Access Compliance Report Public Rights-of-Way (RR Crossings)

Intersection ID: 51371	Main Street: UNIVERSITY_POINTE_BV	Location: N/A
ADA ID: 2C80FD2E3E55	Overall Compliance: No	Severity Score: 0.0
Codes/Mitigation Info/Possible Solution		Field Measurements/Component Compliance

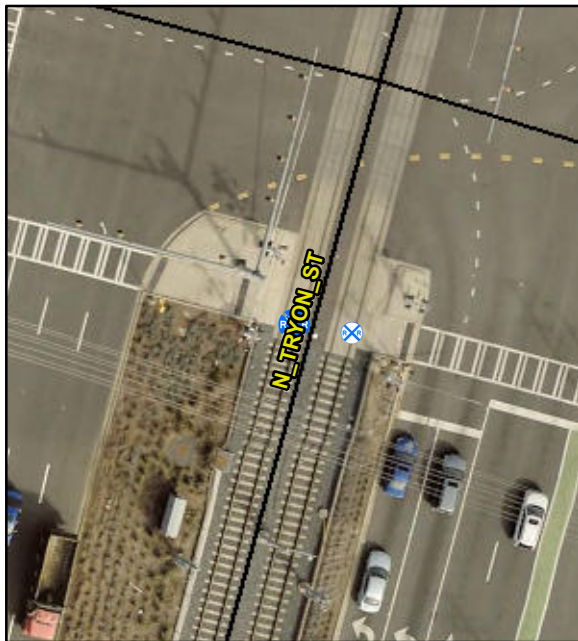
Compliance	Description	Data
Yes	DWS Provided?	Yes
Yes	DWS Contrast?	Yes
Yes	DWS Width (in)	Yes
Yes	DWS Length (in)	24.5
Yes	DWS Offset (in)	159.0
Yes	Pedestrian Gate?	Yes
N/A	DWS Outside Gate?	Yes
N/A	Rail Type?	LightRail
No	Flangeway Gap (in)	2.8
Yes	Sidewalk Width (in)	120.0

**Remove & Replace Walking Surface
Adjacent to Rail.**
